## Technical Note TN-786

### T828 Q2 Component Changes

This technical note applies to Series II T828-10-XXXX power amplifiers fitted with the SD1272 driver transistor. If the existing MRF234 needs to be replaced, the components listed below will need to be changed.

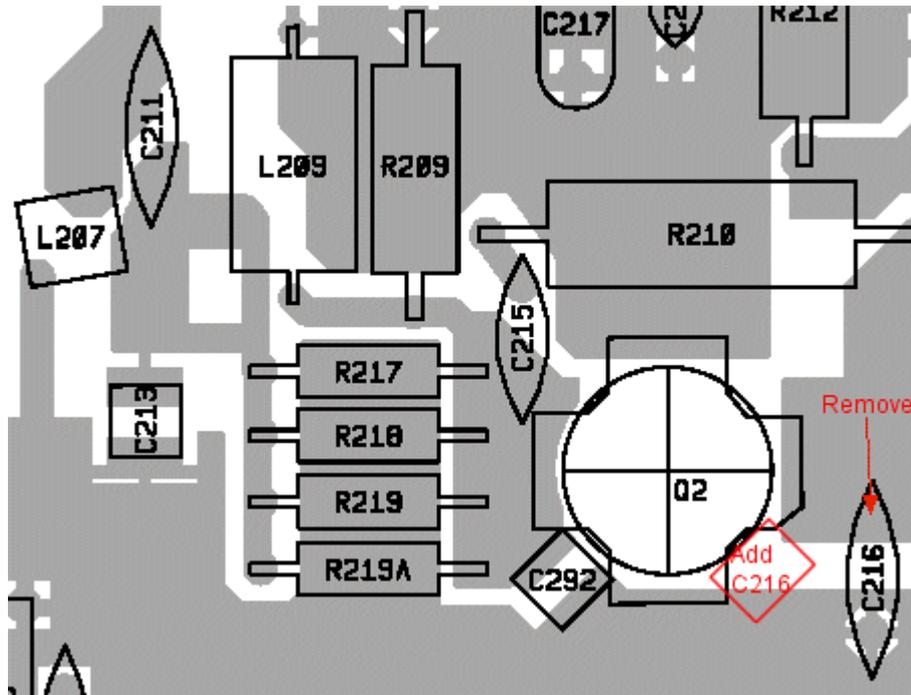
Notes: C216 is removed and replaced with a chip cap as shown below. Other components are in their original locations.

Circuit Symbol	Current Component	Modified Component
Q2	MRF234 ipn: 000-00030-74	SD1272 ipn: 000-00127-20
C216	68pF ipn: 010-02680-00	150pF ipn: 015-03150-03
R217	1ohm ipn: 030-01100-10	2.2ohm ipn: 030-01220-00
R218	1ohm ipn: 030-01100-10	2.2ohm ipn: 030-01220-00
R219	1ohm ipn: 030-01100-10	2.2ohm ipn: 030-01220-00
R219A	1ohm ipn: 030-01100-10	2.2ohm ipn: 030-01220-00
L207	4.5T/3.0 ipn: 052-08130-45	2.5T/3.5 ipn: 052-08135-25
C211	120pF ipn: 011-53120-01	150pF ipn: 011-53150-01
